UNITED STATES PATENT AND TRADEMARK OFFICE

| APPLICATION NO. | FILING DATE | FIRST NAMED INVENTOR | ATTORNEY DOCKET NO. | CONFIRMATION NO. |
|-----------------|-------------|----------------------|---------------------|------------------|
| 10/633,496 | 08/05/2003 | Ben Hsu | BHT-3125-156 | 5199 |

| Office Action Summary | Application No. 10/633,496 | Applicant(s) HSU, BEN | |

DETAILED ACTION

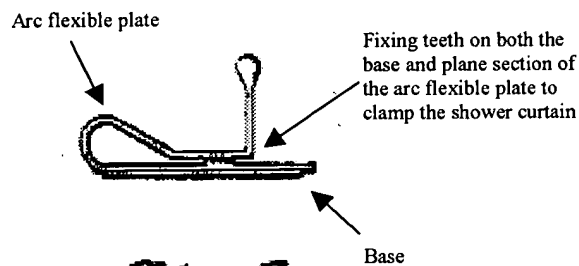
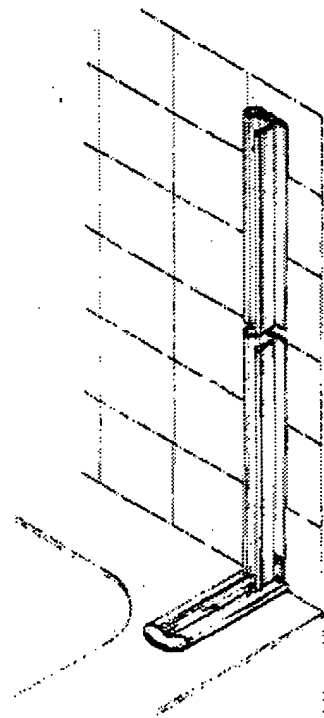
However, Cairns (figure 5) teaches fixing clip structure 100 for a shower curtain 138 wherein it is advantageous to utilize double-sided adhesive tape 146 for ease of assembly.

As ease of assembly of the fixing clip of Olson is desirable in order to be efficient, it would have been obvious to modify the fixing clip of Olson so as to utilize double-sided adhesive tape as suggested by Cairns so as to make assembly easier.

*Fig. 3.**Fig. 1.**Fig. 2.**Fig. 8.*

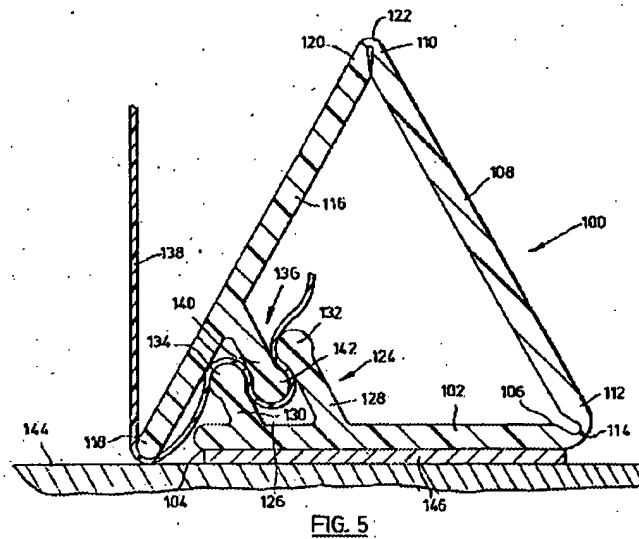
Claims 1-4 are rejected under 35 U.S.C. 103(a) as being unpatentable over Olson (US D284024) in view of Cairns (US 4887324).

Olson (figures 1-3, 8) teaches a side hook for a shower curtain, mainly made up of a fixing clip having a base and an arc flexible plate disposed at the other side thereof in clamping abutment with the base thereof wherein a clamping passage is defined at the bottom ends of the base and the arc flexible plate there-between for both lateral sides of a shower curtain to be pushed there-through for clamping location at the fixing clip therein.

One having ordinary skill in the art would recognize that Olson suggests an adhesive layer on the base to secure it to the shower stall wall. However, this is not stated in Olson. The difference is that a double-sided adhesive tape is not used on the base to secure it to the shower stall.
